Town of Arlington, MA Redevelopment Board

Agenda & Meeting Notice August 17, 2020

Docket #3602, 1207-1211 Mass Ave

To: Jennifer Raitt, Director of Planning and Community Development
From: Kelly Lynema, Senior Planner
Date: August 12, 2020
RE: Shadow Study for Docket #3602, 1207-1211 Massachusetts Avenue

Site Layout Plan

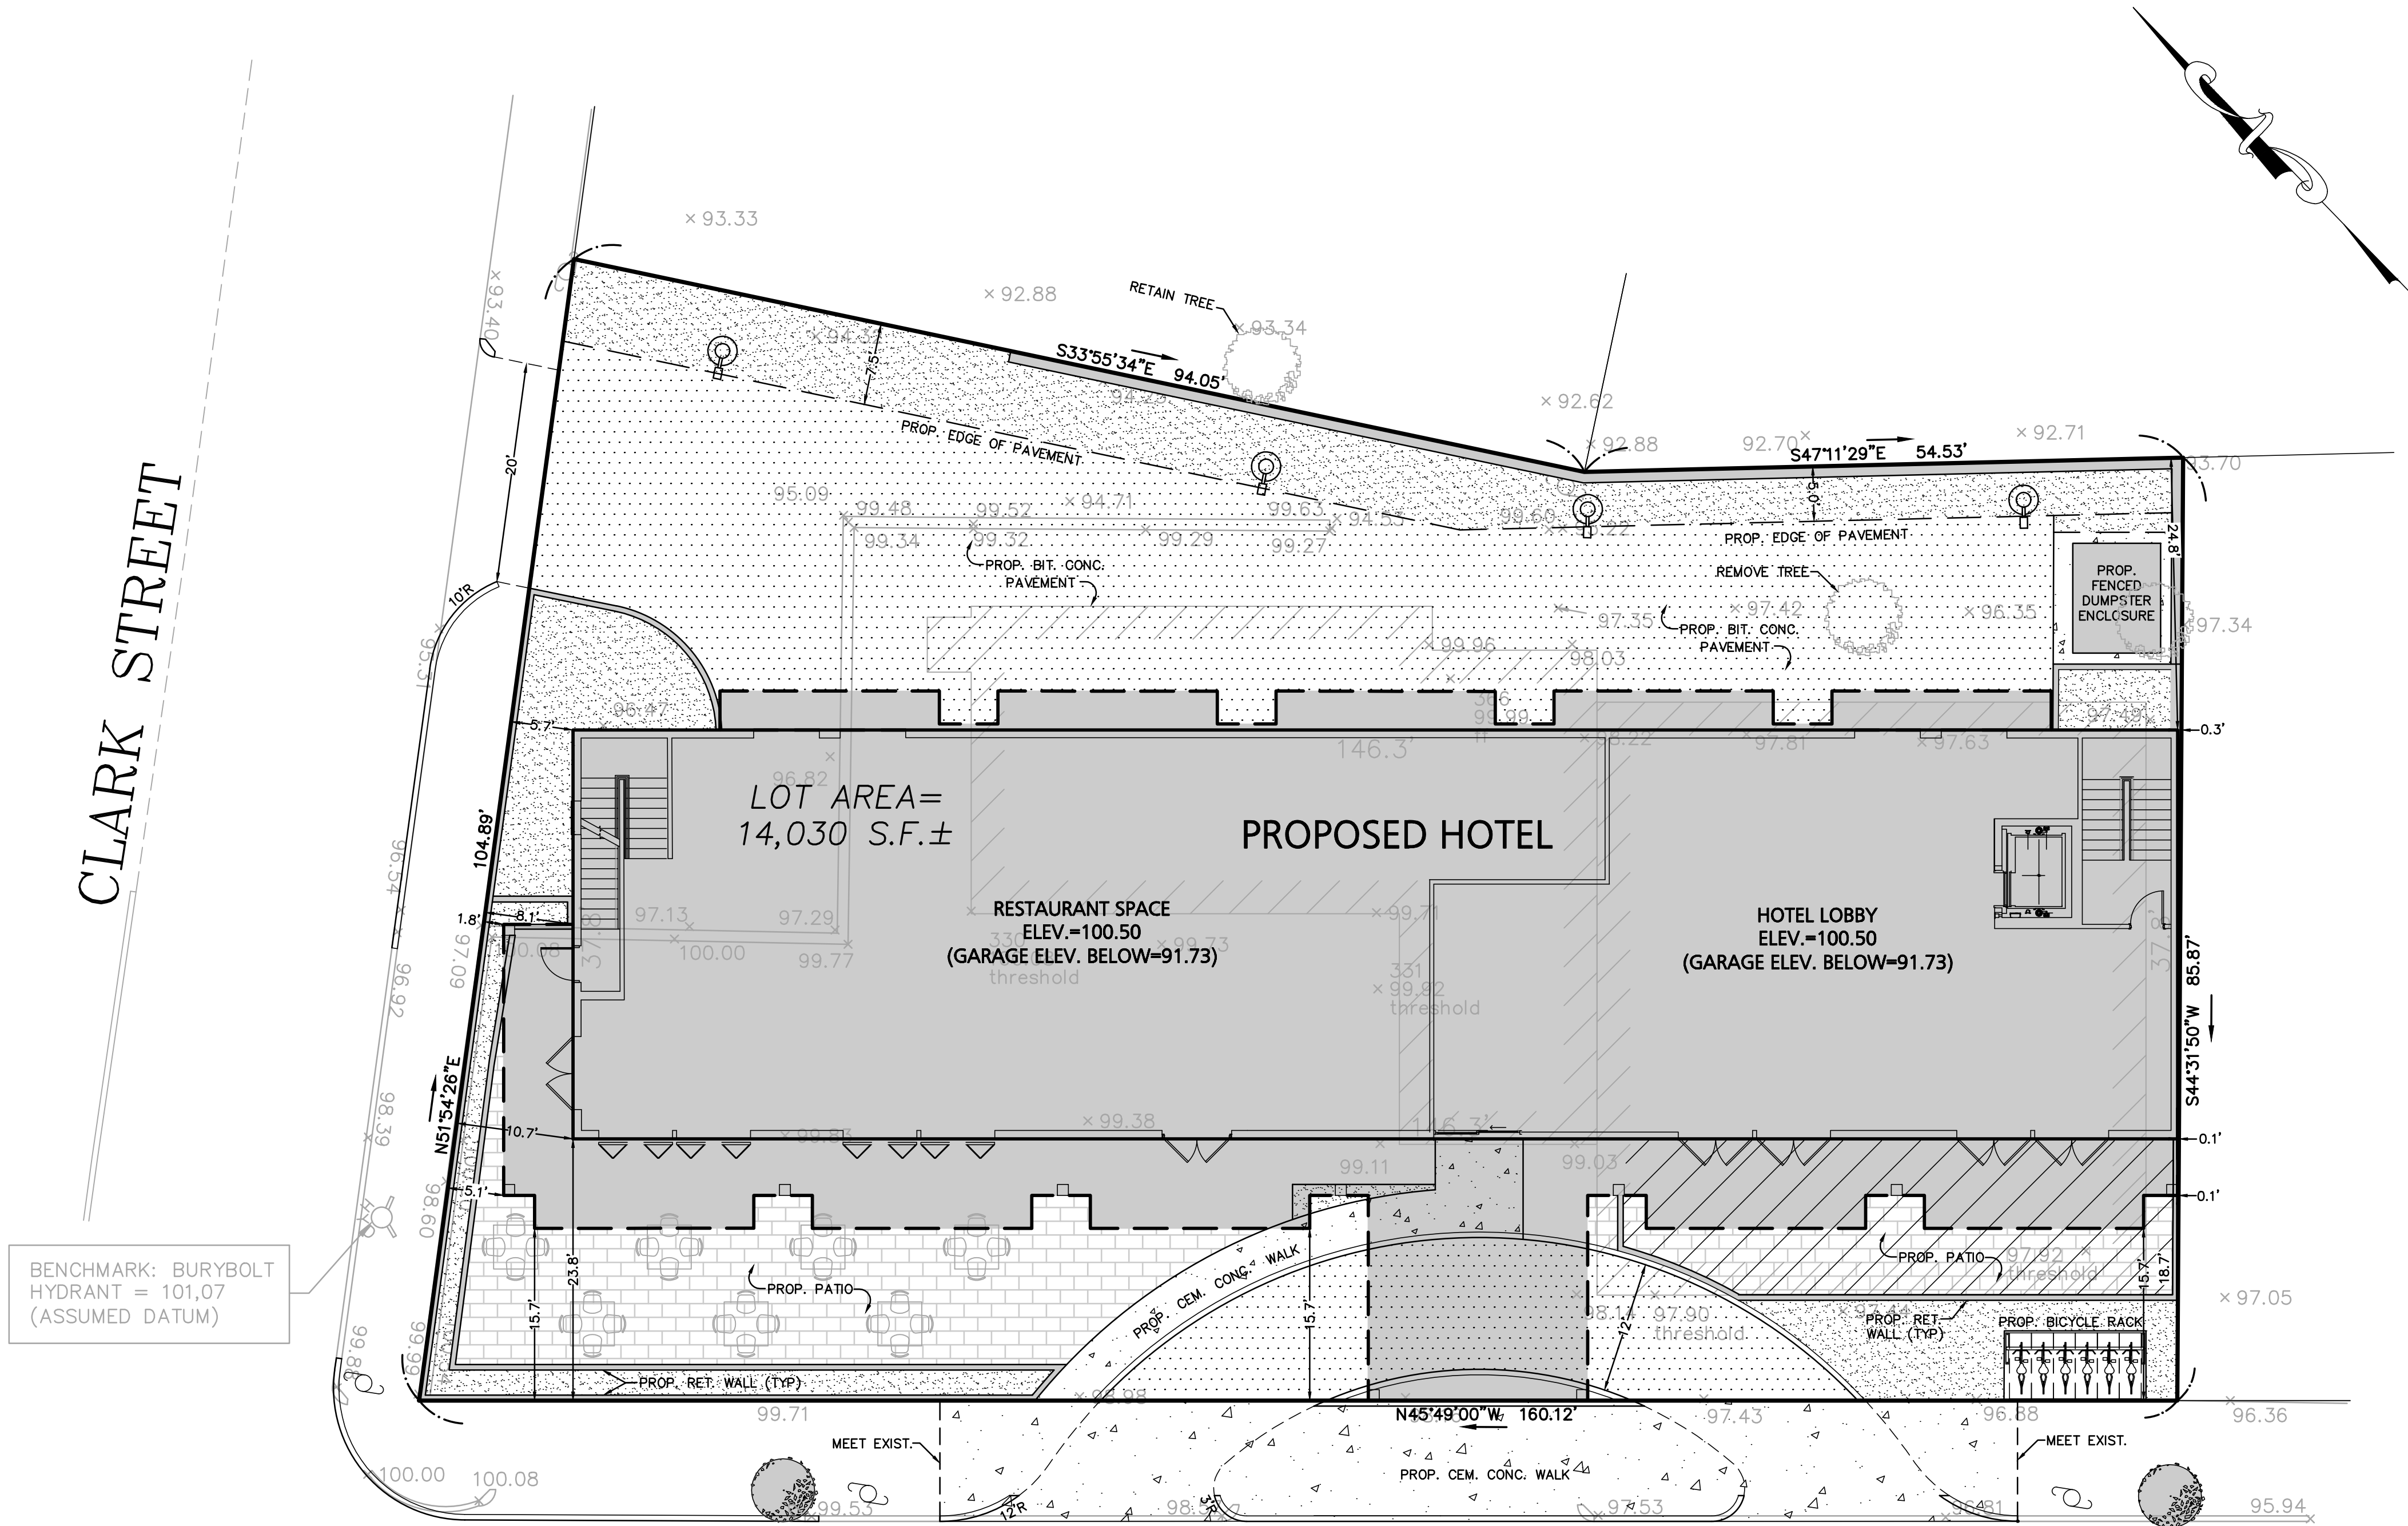
Pursuant to the Board’s request, Plan C-2 – the site layout plan, provides additional detail as to the driveway, including the slope and driveway clearance. As previously noted, the driveway slope is well below Department of Transportation requirements.

L1.2

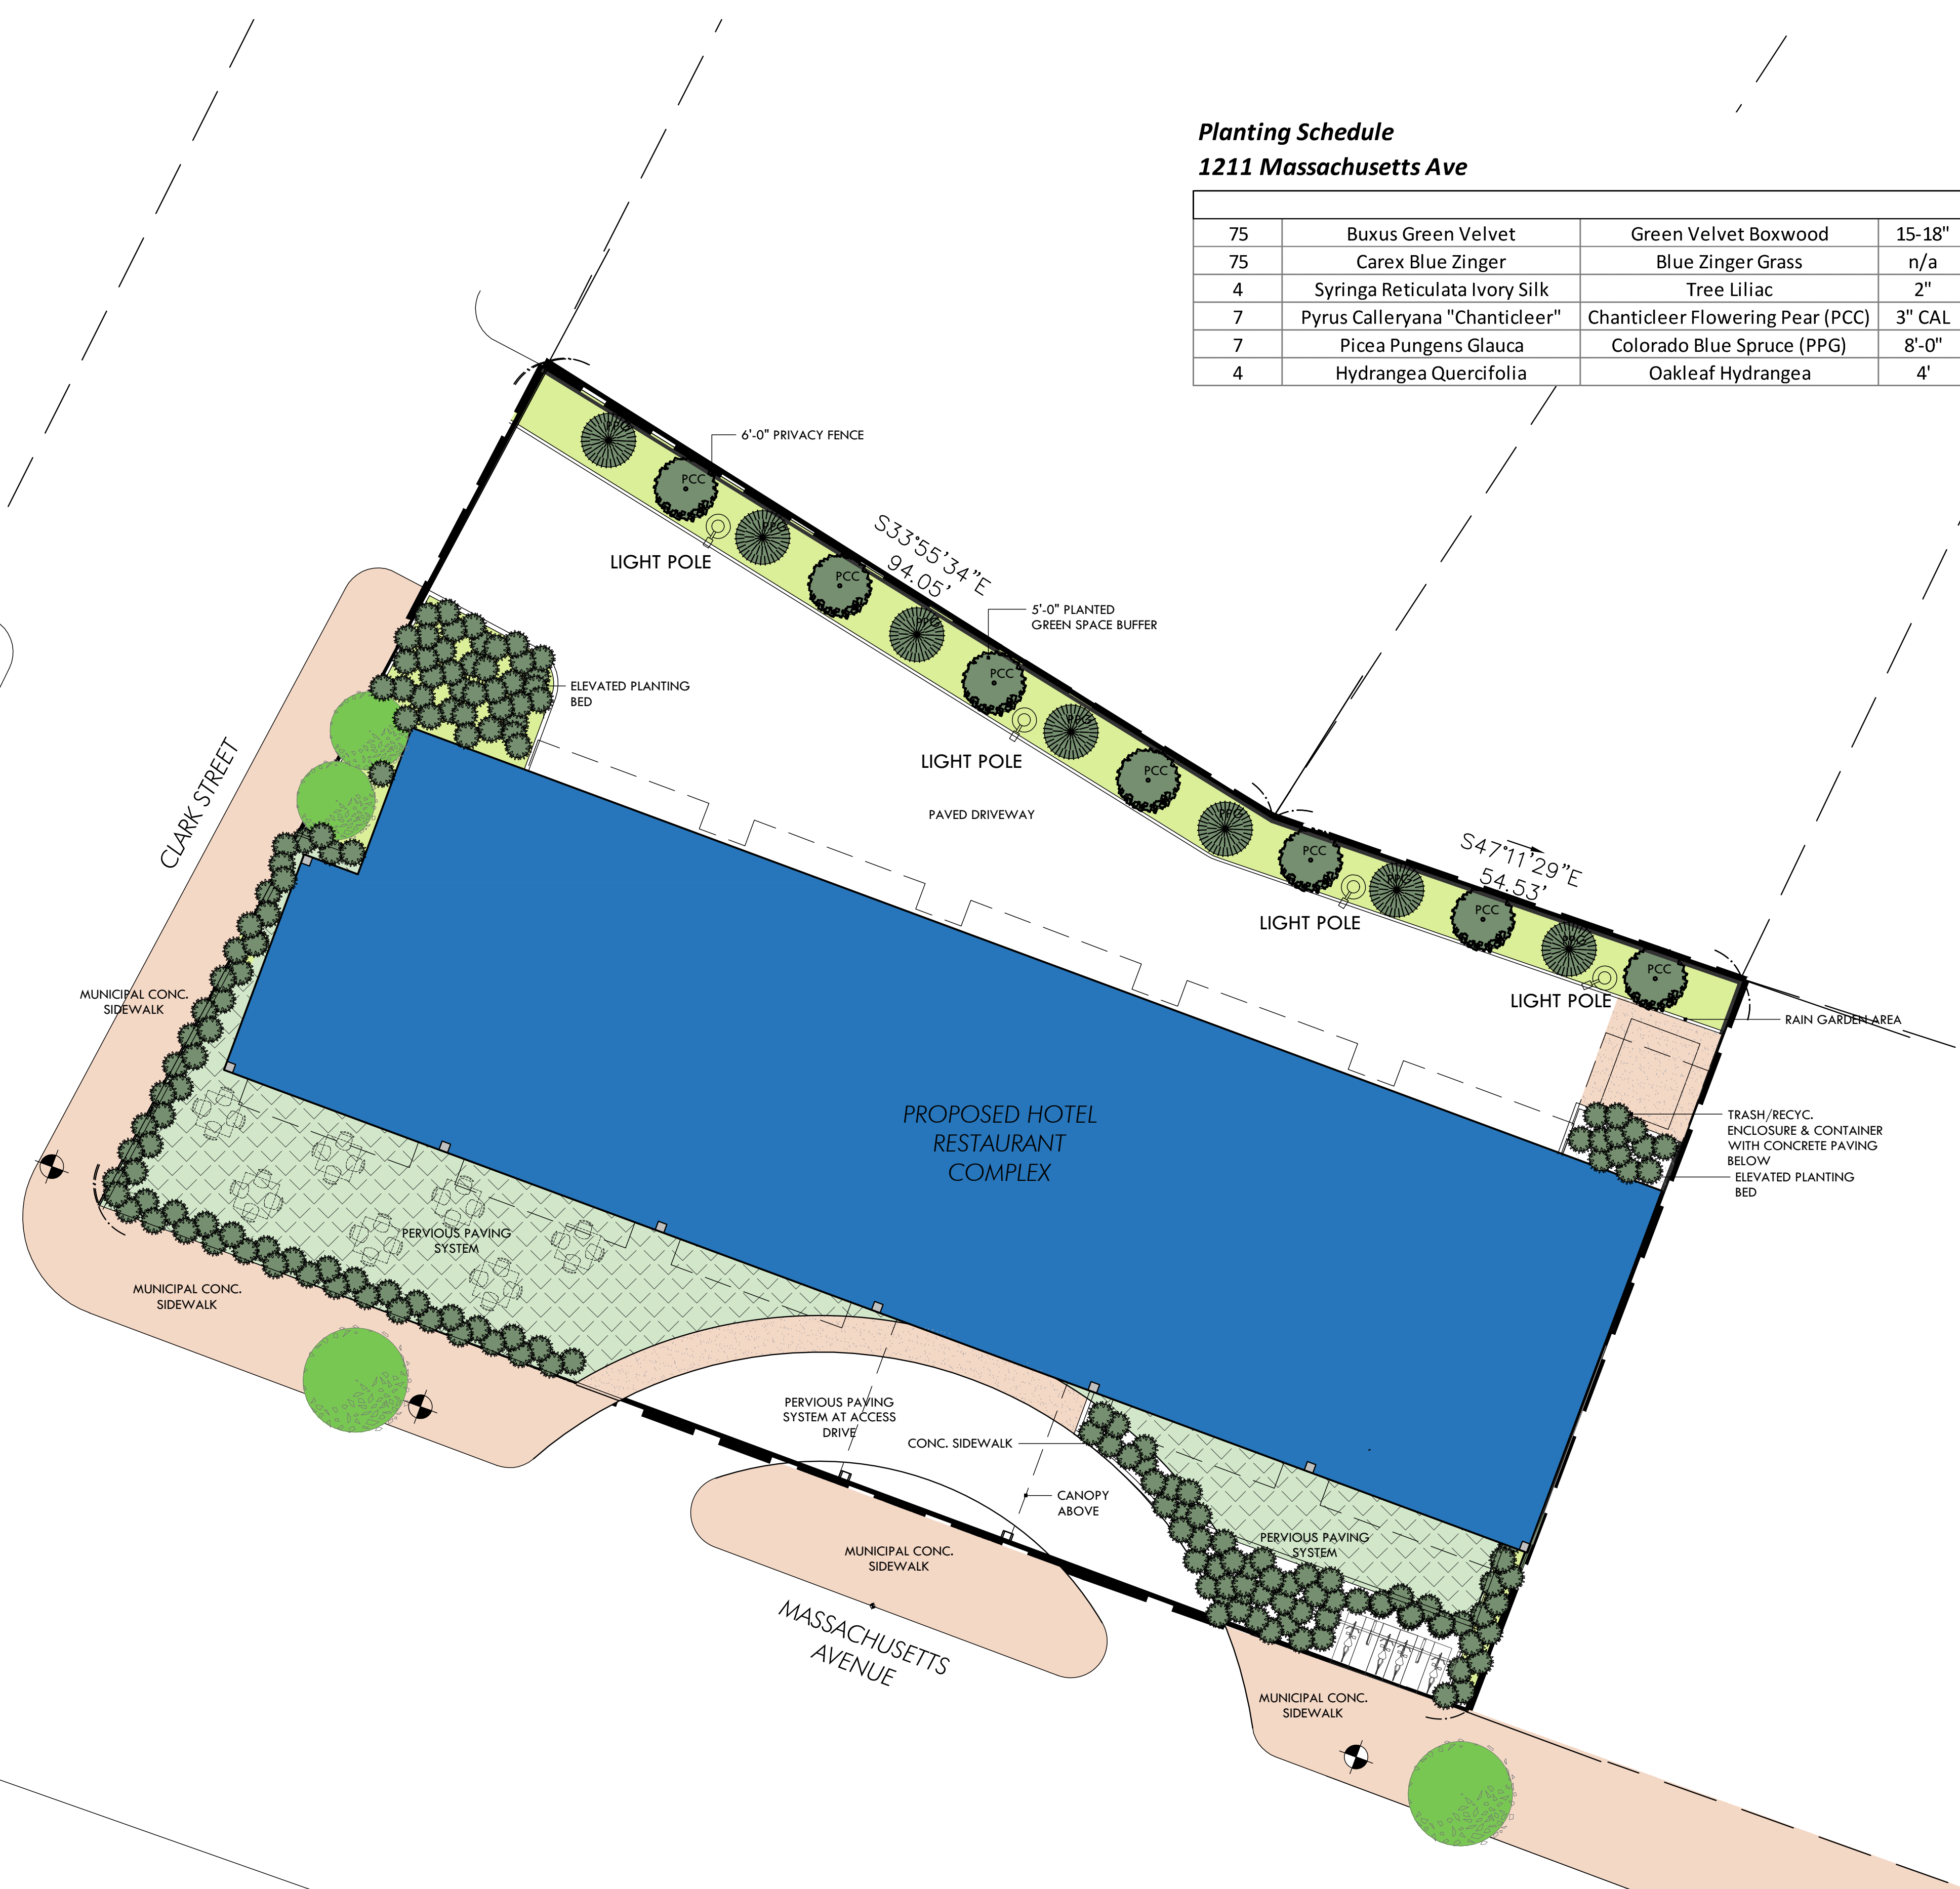
The landscape plan attached as L1.2 identifies the proposed trees and plantings and the sizes.

Valet Parking Figure

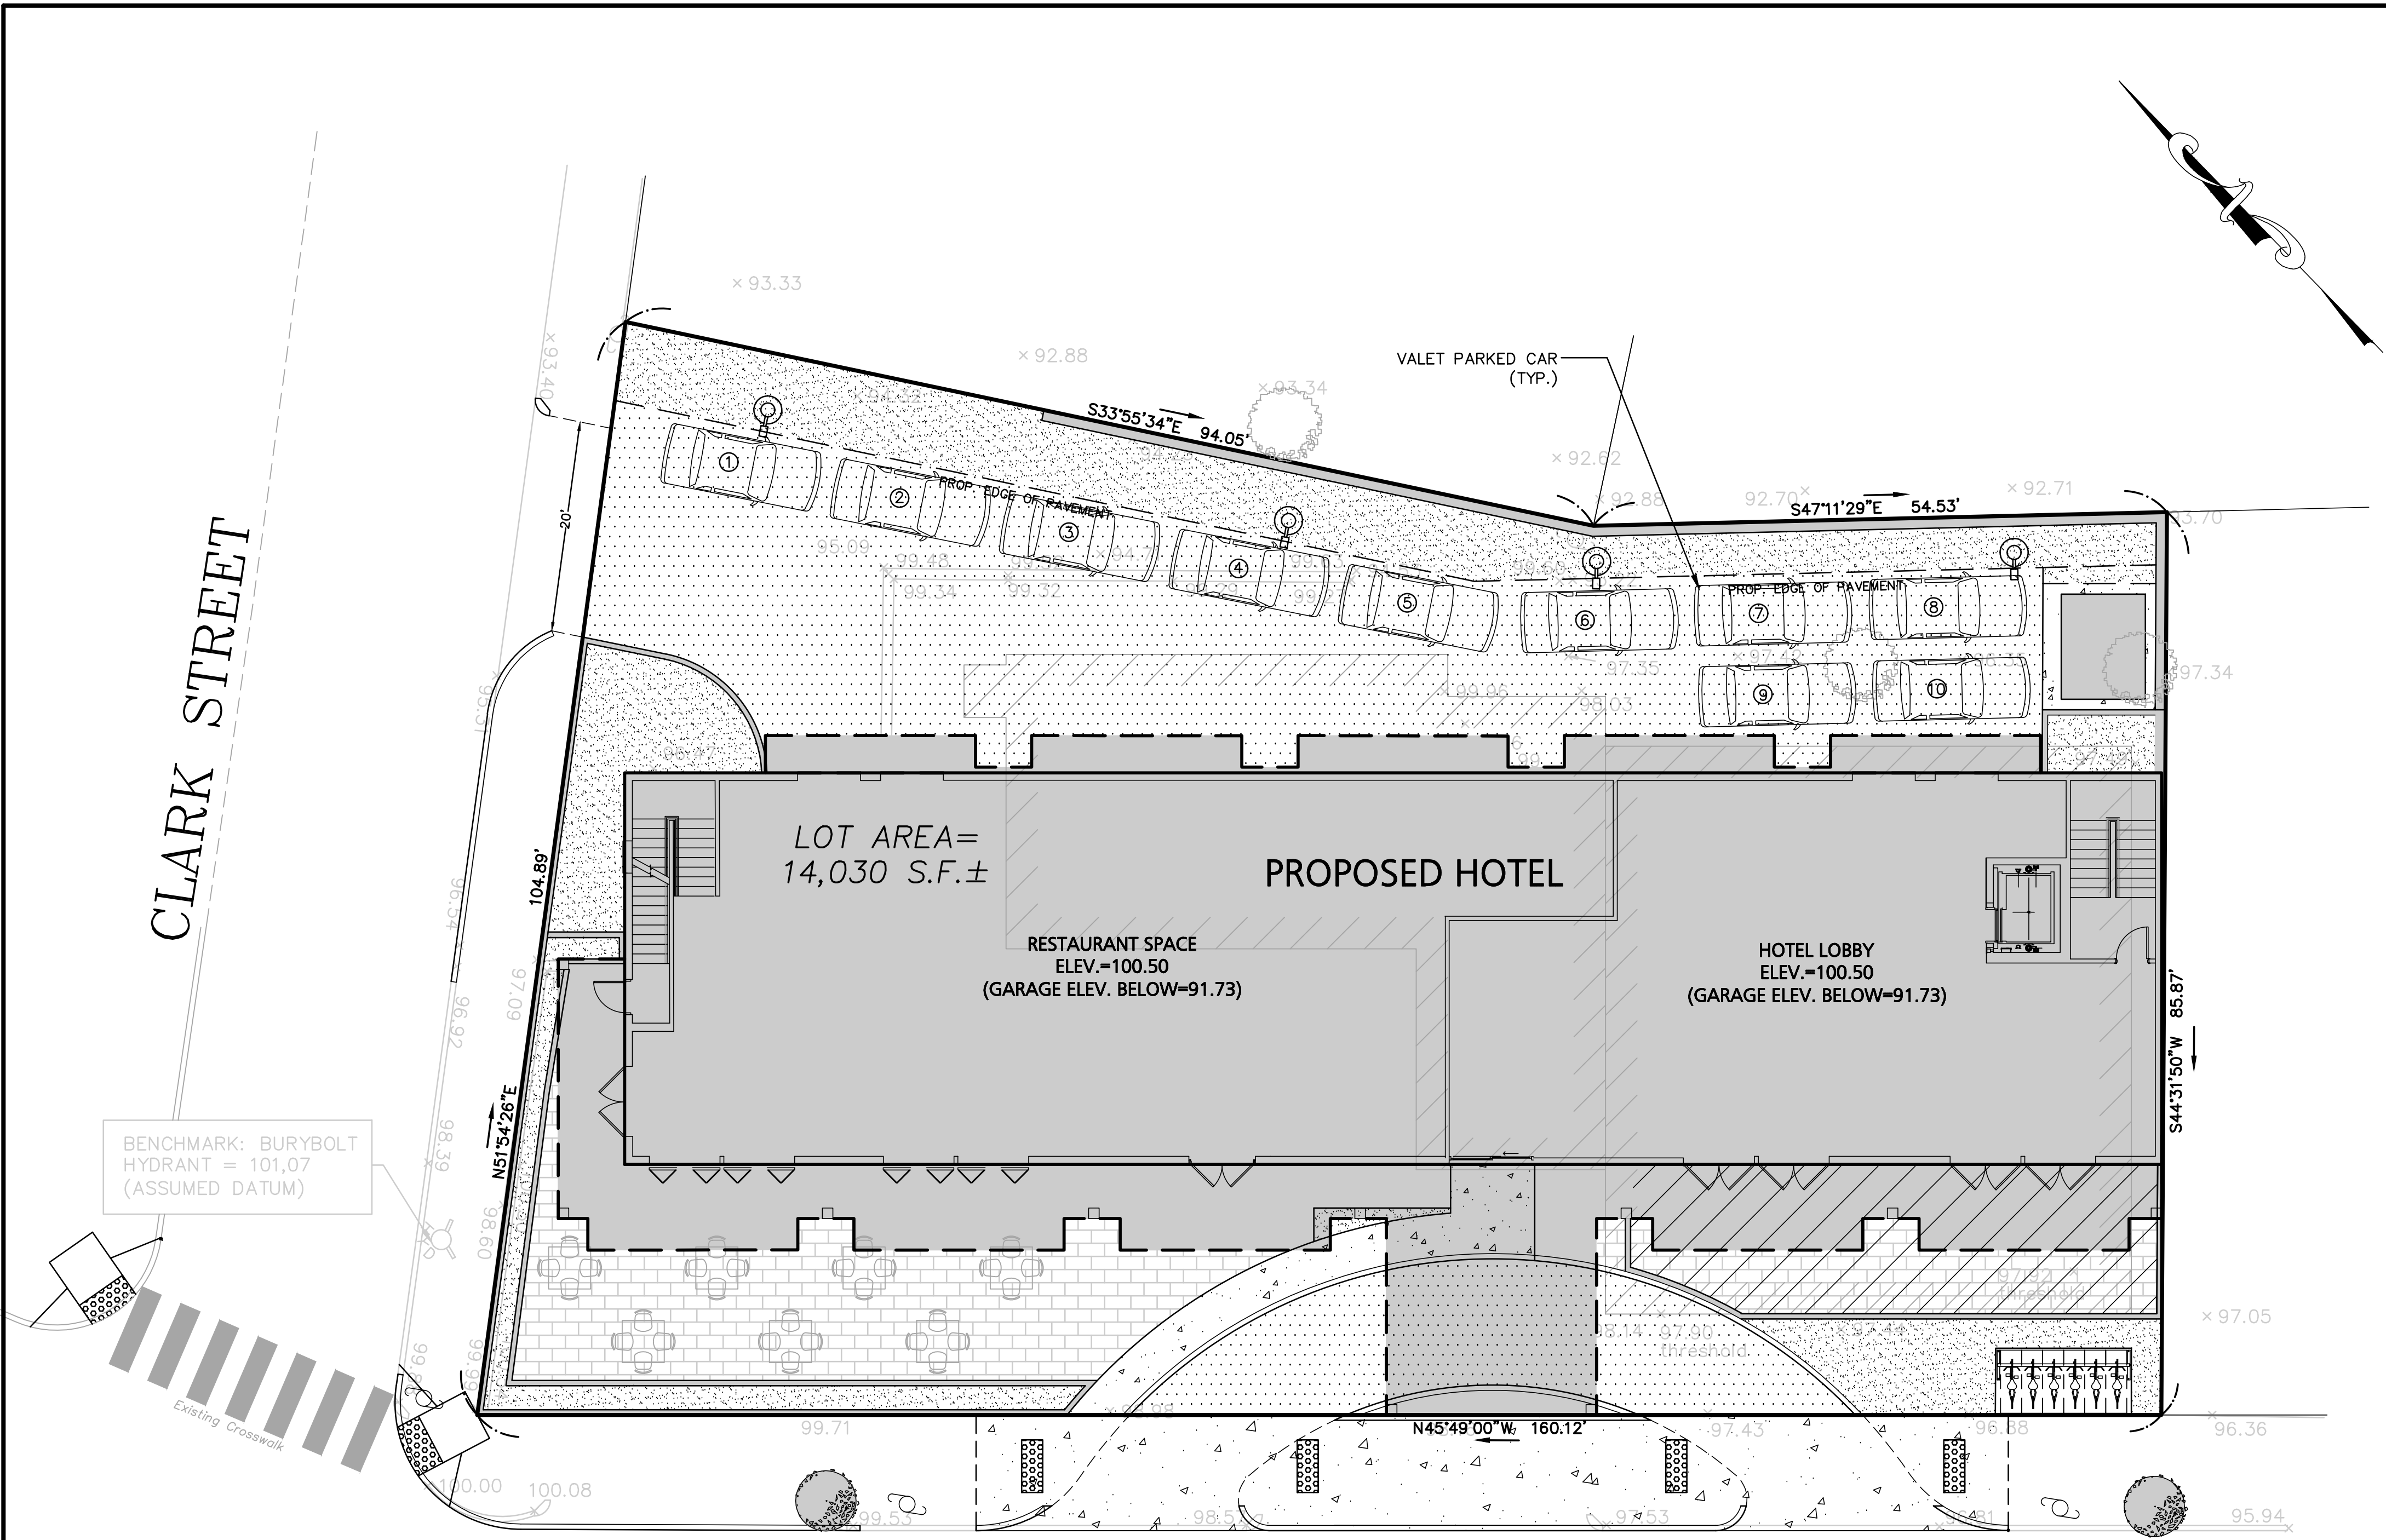
ADD EXIST. CROSSWALK AND DETECTABLE WARNING PANELS AT DRIVEWAYS
